Informational-FIELD SERVICE BULLETIN

FSB Number: LVCCFSB2004-84 (Rev. C)
 Author: Tony Bryan
 Date: June 02, 2005
 Total No. of Pages: 4
 Subject: GSM Triplets – Display Compatibility
 Phone Models: GSM V300, V303, V400, V500, V505, V525, V600
 Level of Repair: 3

TF (Transflective) Type Displays: V300 and V600 Only!

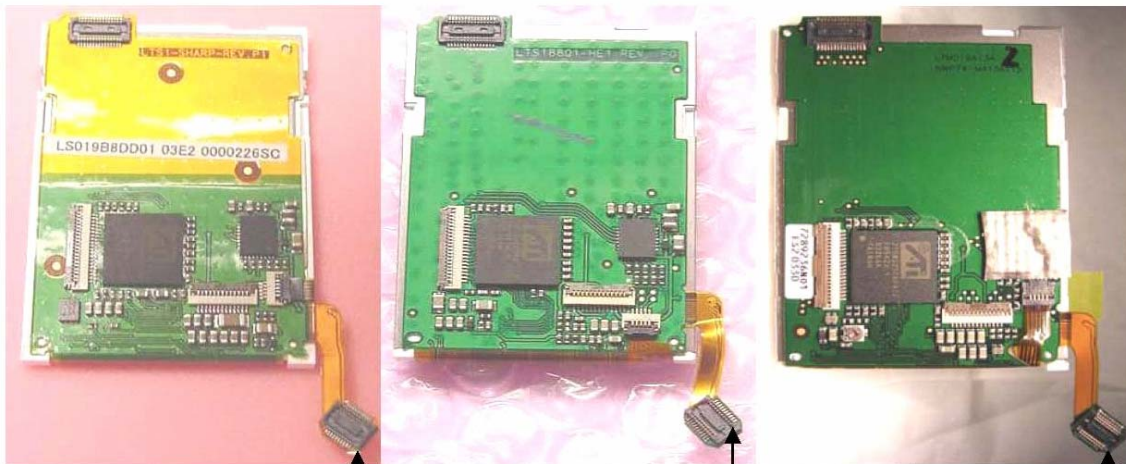
All of the TF Display Modules listed above will require the Fun Light Flex to be removed prior to being used with V300 Models. The flex cable needs to be cut along the edge of the fiberglass board. The recommended tool to cut the flex away from the display's PCB is a pair of rubber-handled side cutters. The flex should be trimmed, as close as possible to the edge of the fiberglass board, as excess overhang of the flex could possibly short to the chrome edge of the module.

Note: Fun Light Flex- Removed for use on V300
